RESPONSE TO REQUEST FOR ADDITIONAL INFORMATION

APR1400 Design Certification

RAI No.: 457-8558
SRP Section: 09.01.05 - Overhead Heavy Load Handling Systems
Application Section: DCD Subsection 9.1.5
Date of RAI Issue: 04/06/2016

Question No. 09.01.05-10

Figure 1. Load Handling Equipments in Fuel Handling Area

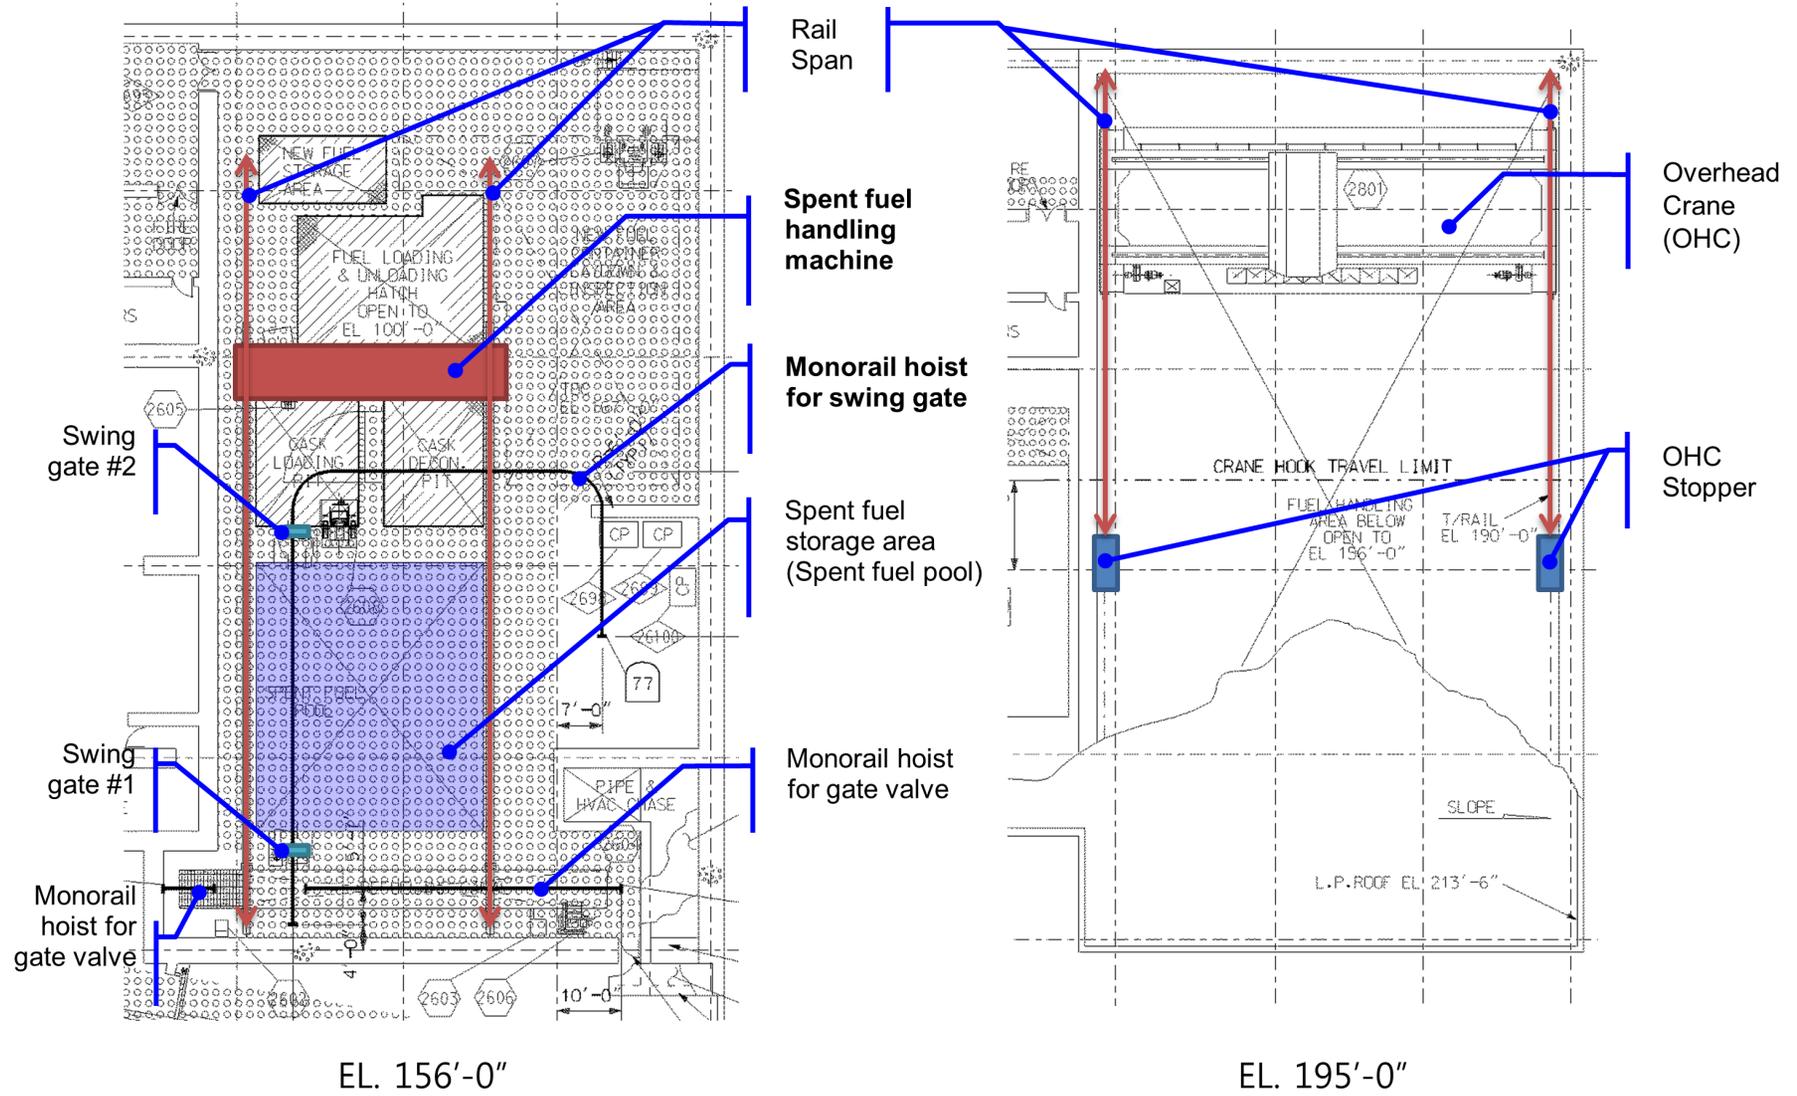
The applicant is requested to identify the crane that is used to handle the spent fuel assembly with its handling tool and a swing gate as discussed in the above response, and revise DCD, Tier 2 Section 9.1.5.3, to reflect that the fuel handling area overhead crane is not “single-failure-proof.”

The spent fuel handling machine handles the spent fuel assembly with its handling tool. The monorail hoist for the swing gate handles the swing gate. Both cranes are shown in Attachment 2.
